RE: **Percolation Testing Report  
3514 Hipsley Mill Road**

RE: 3514 Hipsley Mill Road  
Percolation Certification Plan

PROJECT:  
**HUMPHREYS' RESIDENCE - ADDITION**  
3514 Hipsley Mill Road  
Woodbine, MD 21797

SEPTIC SYSTEM & PERC CERTIFICATION

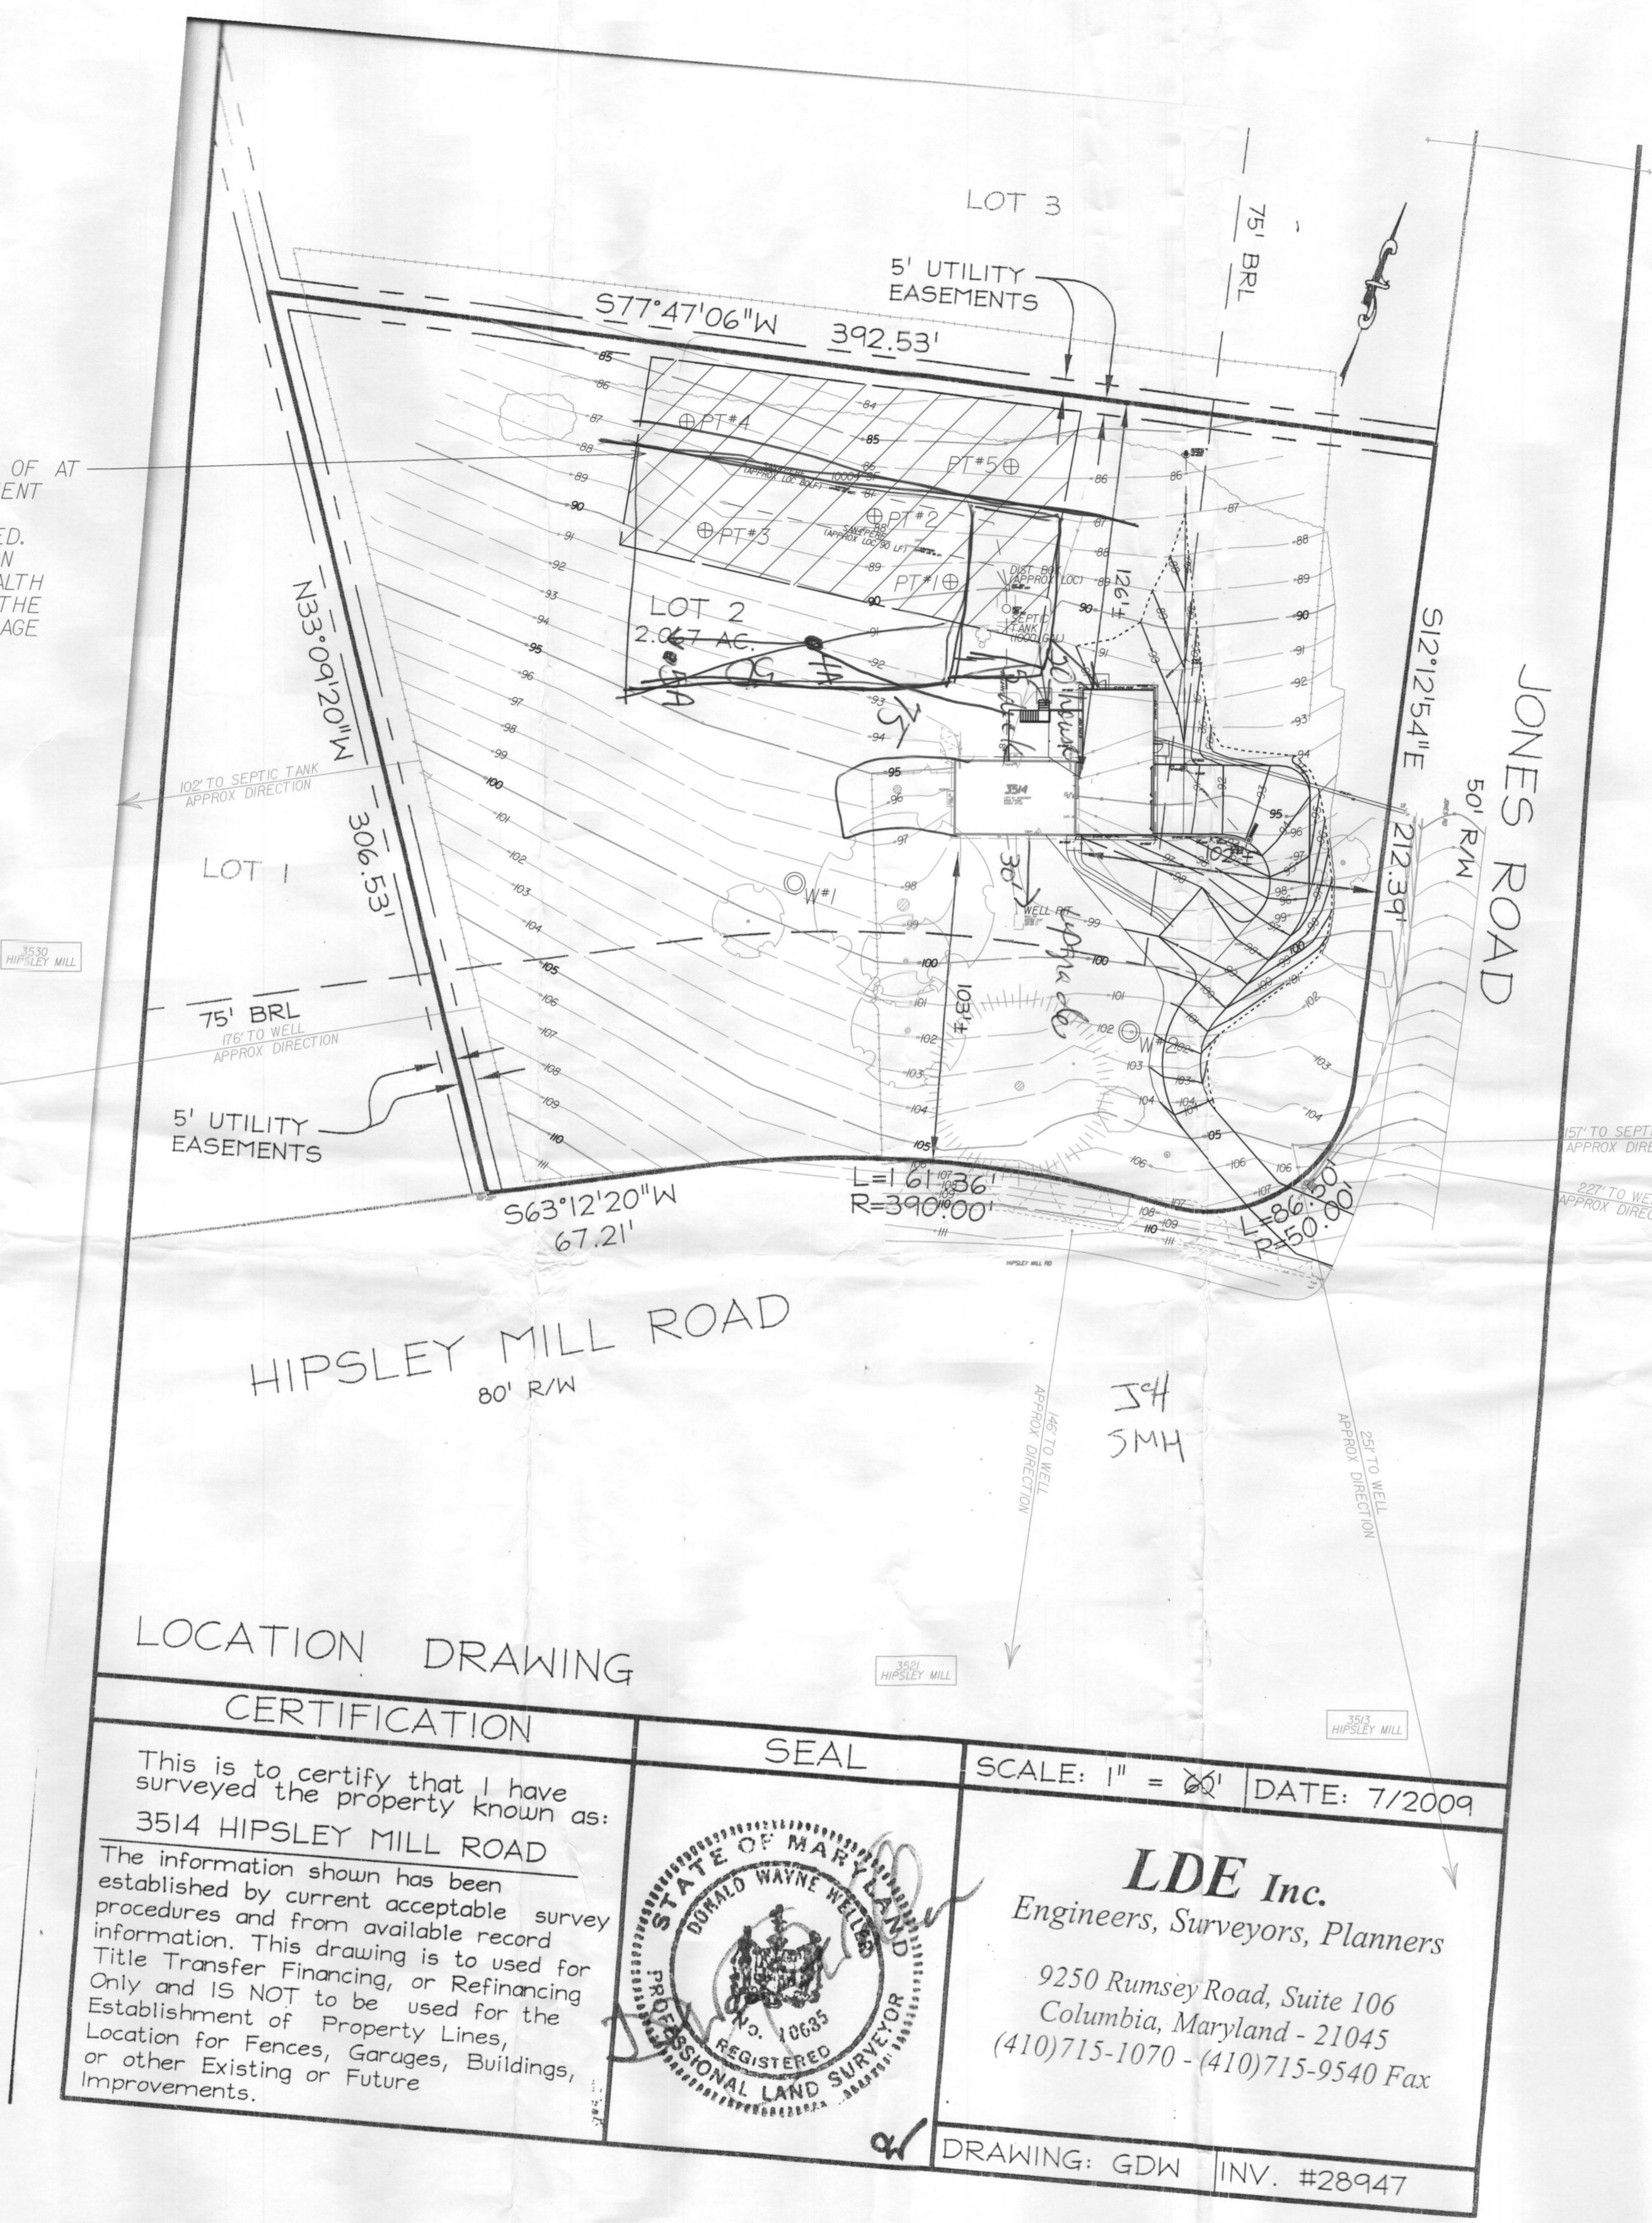
The following comments apply to the plan prepared by LDE, Inc. Engineers, Surveyors, and Planners. Applicant is advised to revise and resubmit.

- ⬇ Five percolation holes are required.
- ⬇ Soil units must be shown on plan.
- ⬇ Topography with elevations.
- ⬇ Show the location of the existing well and show 2 alternate well locations.
- ⬇ Show the location of the existing septic system with all components.

In your purpose statement on your proposed plan, it stated that you will be using this percolation certification plan for your anticipated building application. Therefore, in addition, you must submit floor plans for the existing house and the proposed addition, so the septic system can be properly sized for your anticipated project.

**G-0-05**

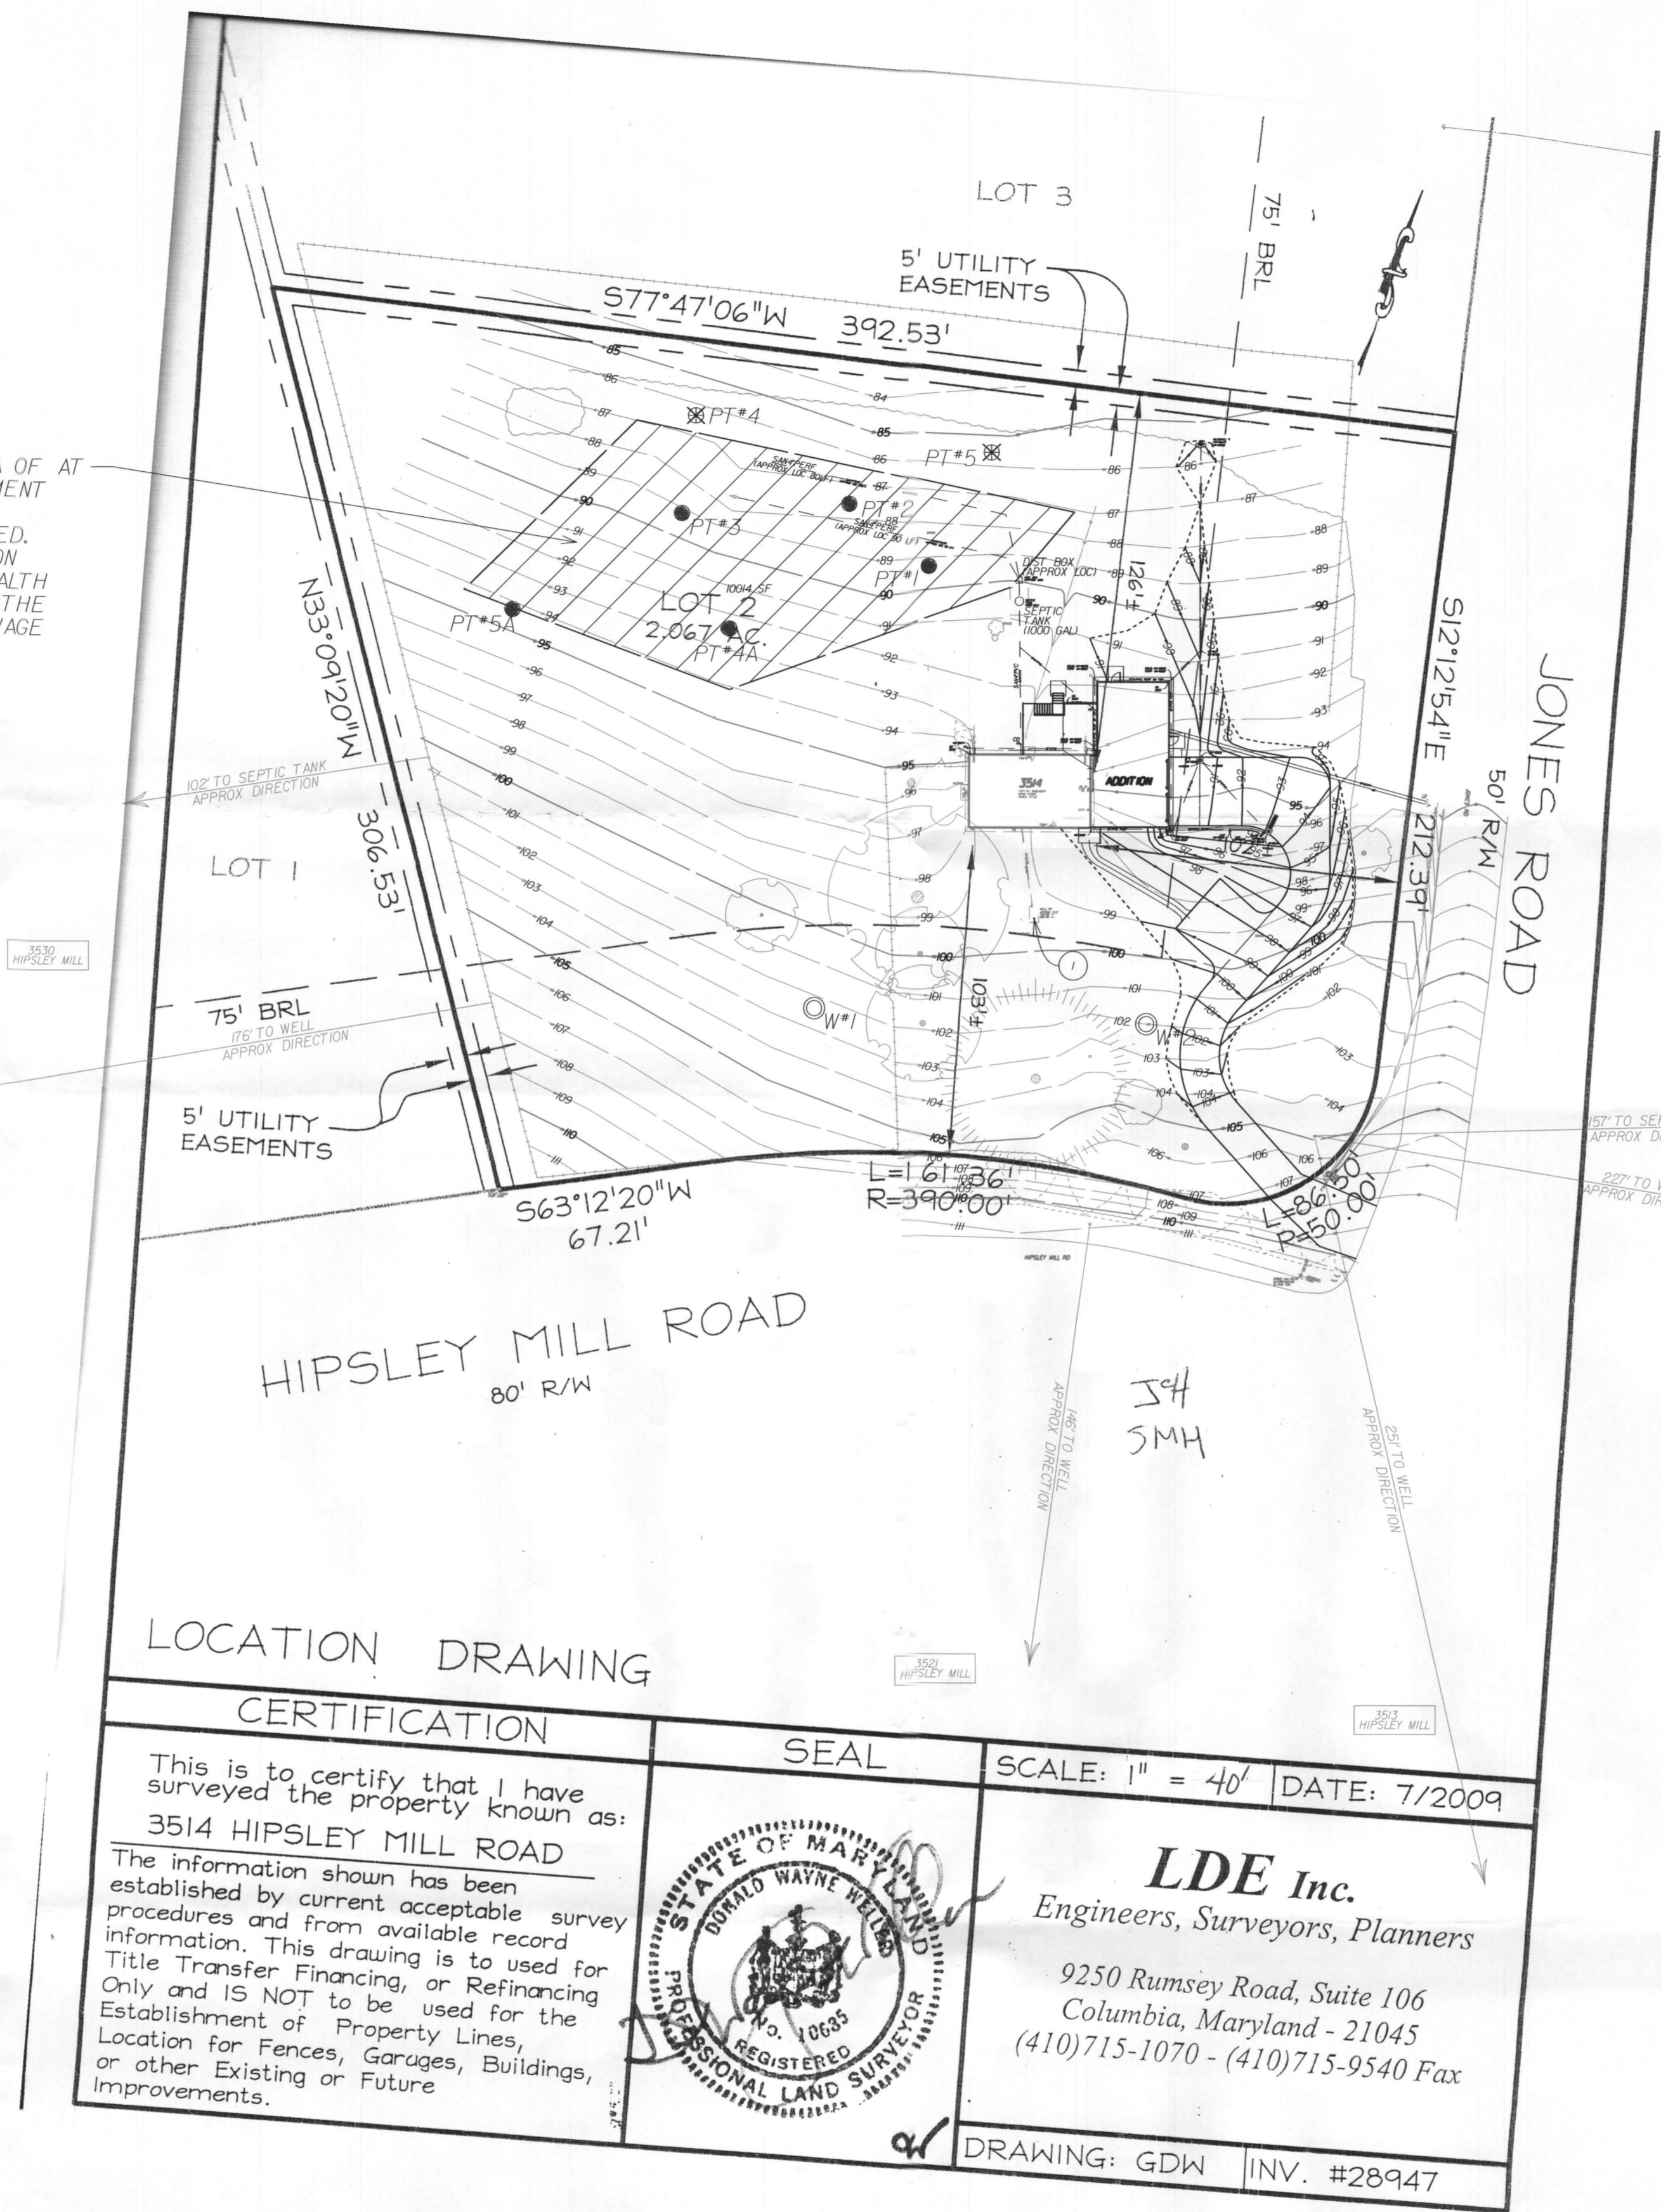
After reviewing your percolation certification plan, I have discovered a few revisions needed in order to proceed with your percolation certification plan.

1. All wells (proposed and existing) must be 100 feet from the septic easement and 30 feet from the house.
2. Well pit must be labeled (to be upgraded).
3. Addition must be labeled.

Remember that you will not have to upgrade your septic tank if you are not adding any additional bedrooms.

- KEYNOTES
1. EXTG WELL CASING & CONDUIT HAS BEEN EXTENDED ABOVE GROUND & FITLESS ADAPTOR INSTALLED. WELL PIT WAS ABANDONED, COLLAPSED & BACKFILLED.
